SUBJECT: REQUEST FOR MODIFICATION OF CONTRACT NO. W-7405-ENG-276, HARSHAW CHEMICAL COMPANY

RADIOACTIVE CONTAMINATION SURVEY
OF URANIUM REFINERY AT
Harshaw Chemical Company
1000 Harvard Boulevard
Cleveland, Ohio

Survey conducted on November 21, 1957

PLANIC
SECOND FLOOR PLAN
SCALE - 4" = 1'

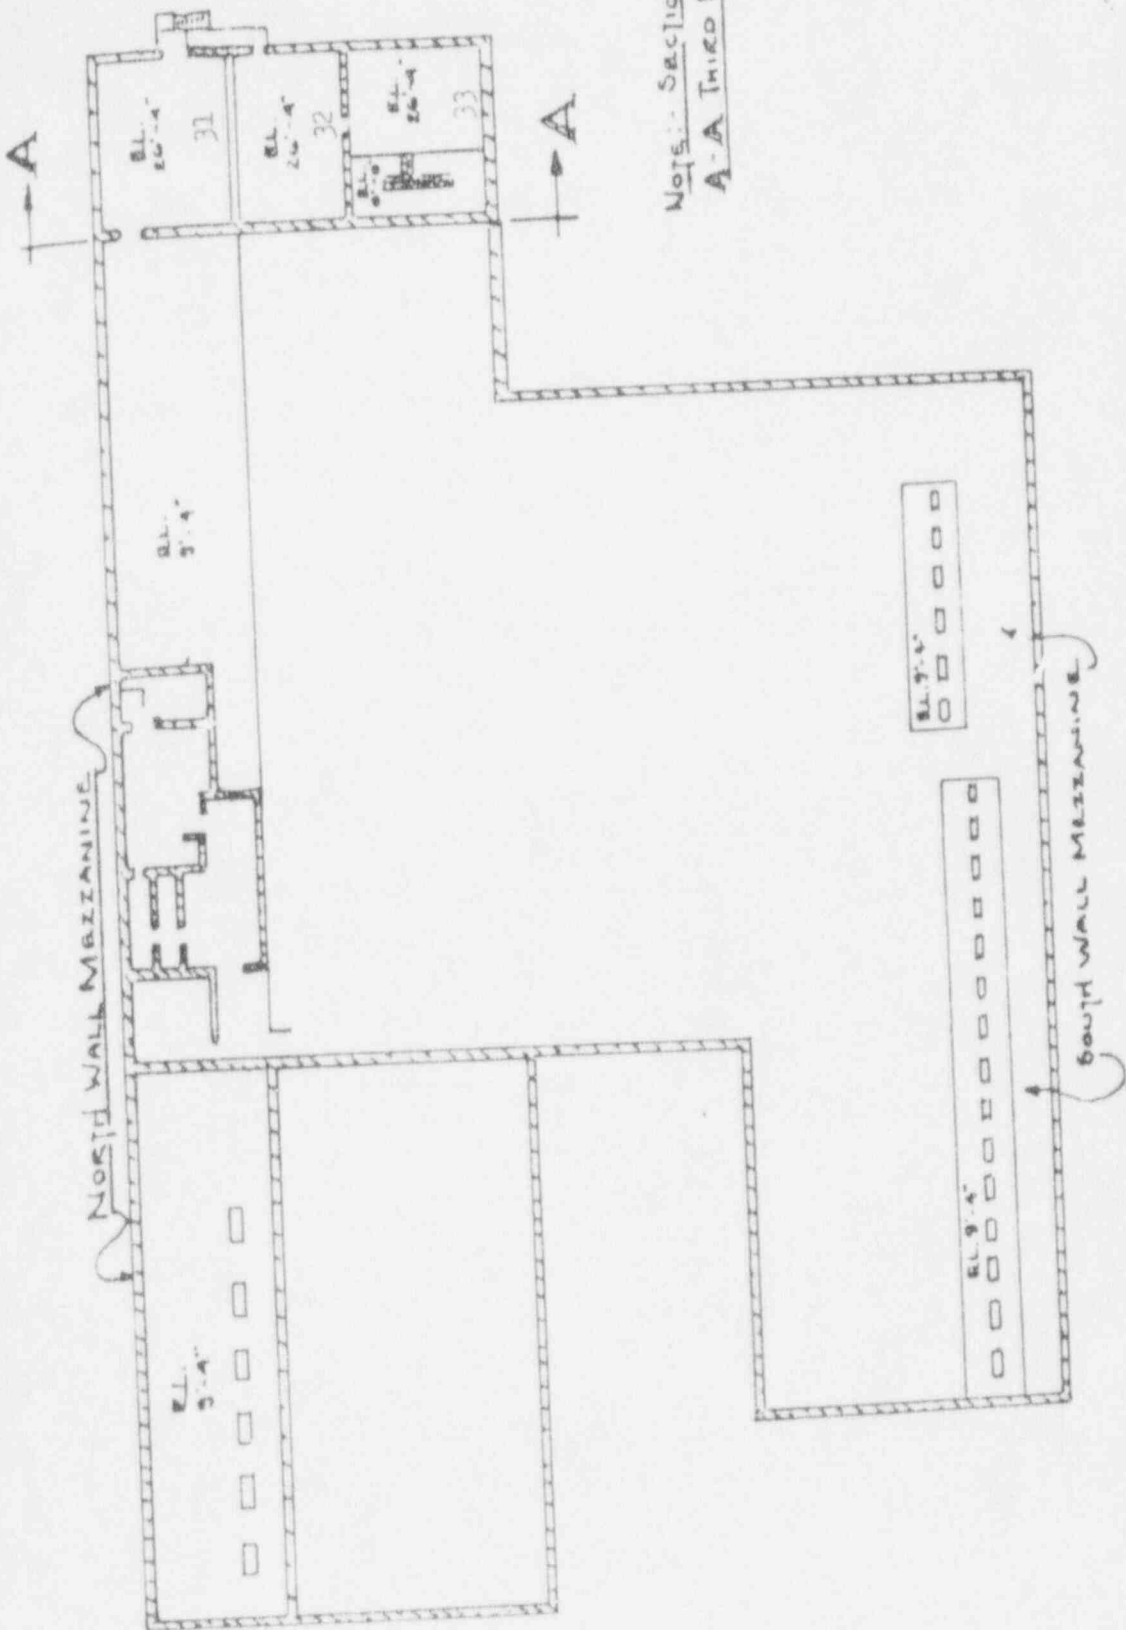
A. The green salt spill in area 21 requires additional decontamination.

B. A lead sink, bench tops and an assortment of used equipments parts are in area 21 (the laboratory) and are obviously contaminated. The lead sink should be discarded, the equipment to be reused should be cleaned and repainted if necessary and the floor in this area should be thoroughly cleaned.
